TOWN OF KITTERY

Planning Review Notes March 14, 2024

ITEM 1—120 Route 1—Major Site Plan — Final Review

SUBJECT: Response to CMA Engineers, Inc. Comments – 11/6/2023
Proposed Hotel Development
Tax Map 14, Lots 10, 12 & 12A

EROSION & SEDIMENT CONTROL PLAN
SCALE: 1"=20'
PROJECT NO. NEX-2200380
11 OF 18

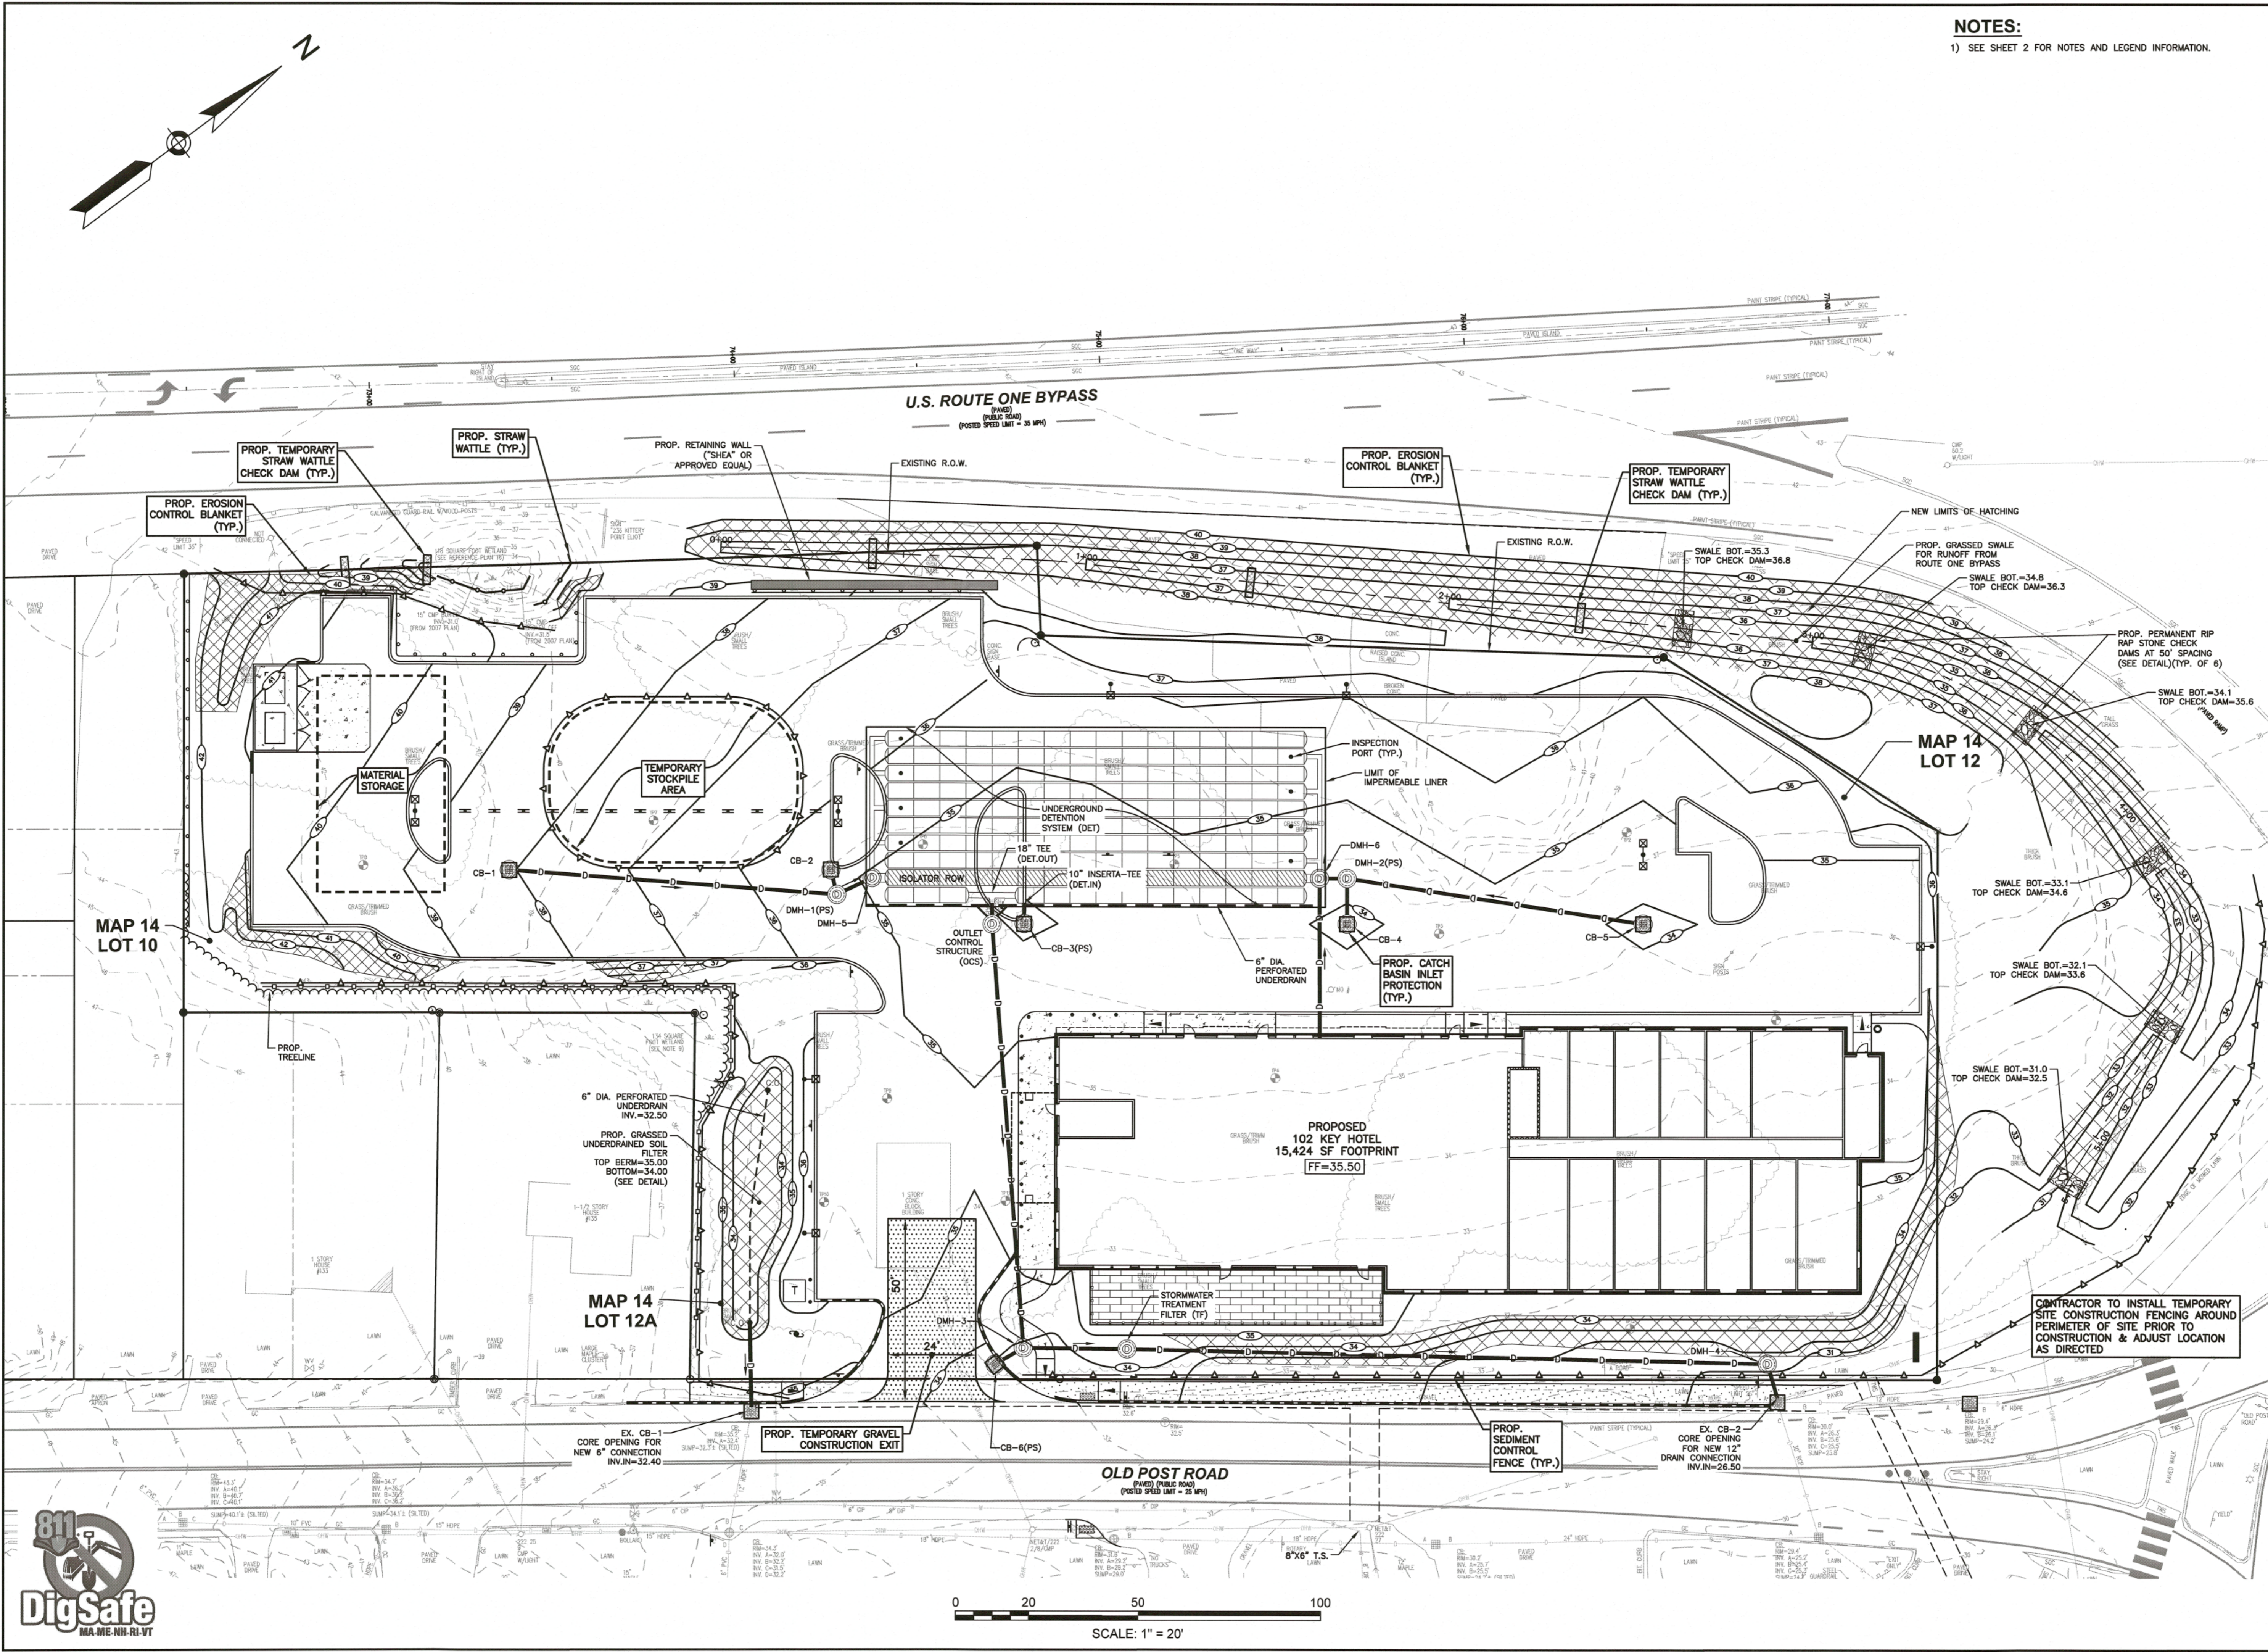
103 9. The table of contents has a note saying" to prevent tracking of sediment onto the existing
104 roads, construction traffic can only exit on the construction exist show on the erosion control
105 plan. Staff suggest this note be included on the erosion plan itself, not just the table of
106 contents.

1,500 GALLON GREASE TRAP DETAIL
(H-20 LOADING)

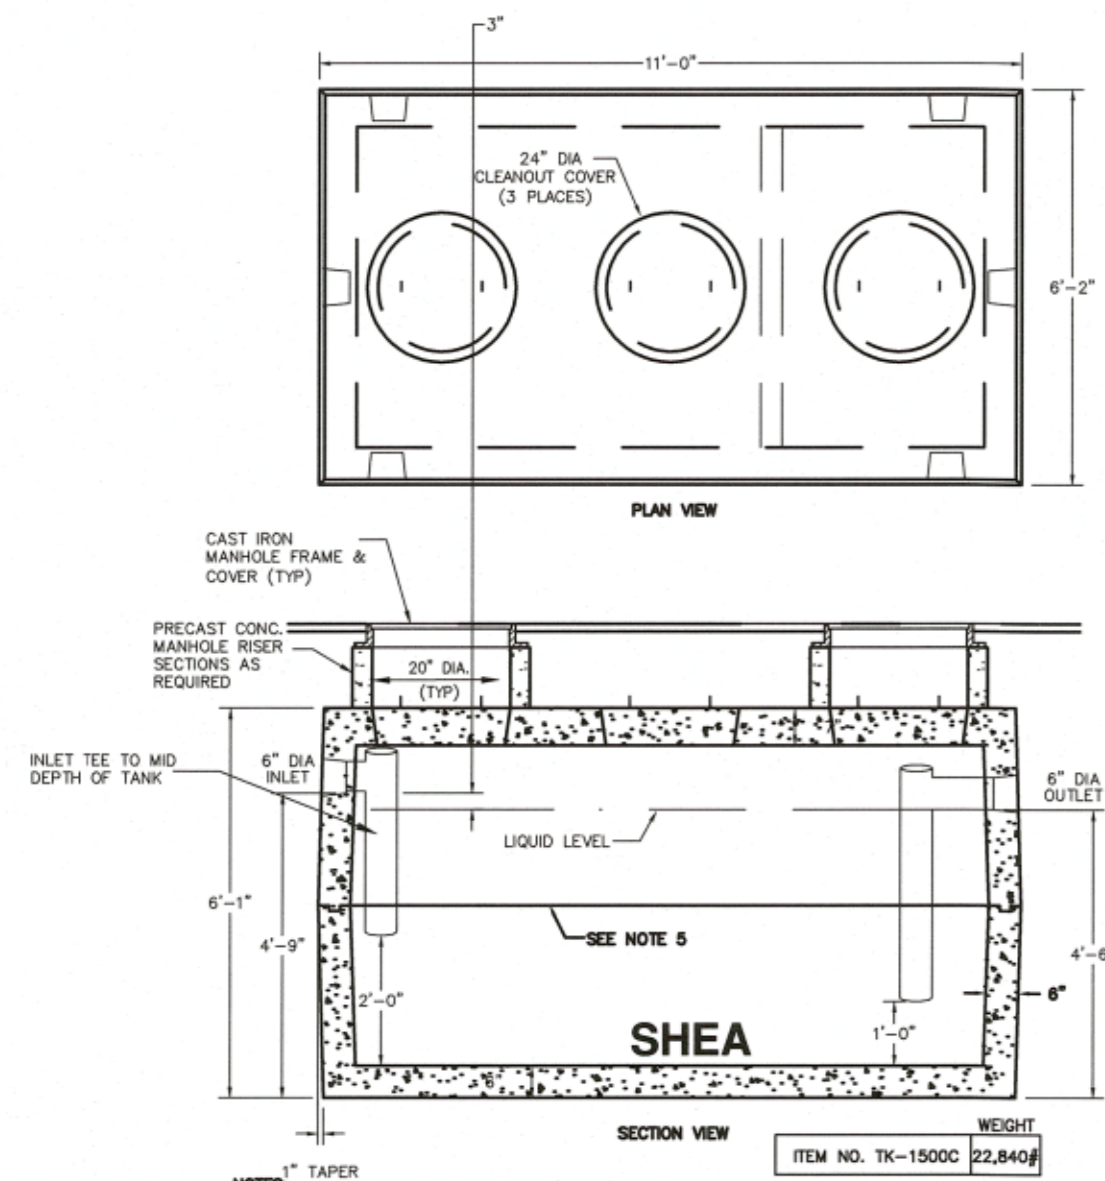
1. The detail is for a 3,000-gallon grease trap but Sheet 10 indicates it is 1,500 gallons.
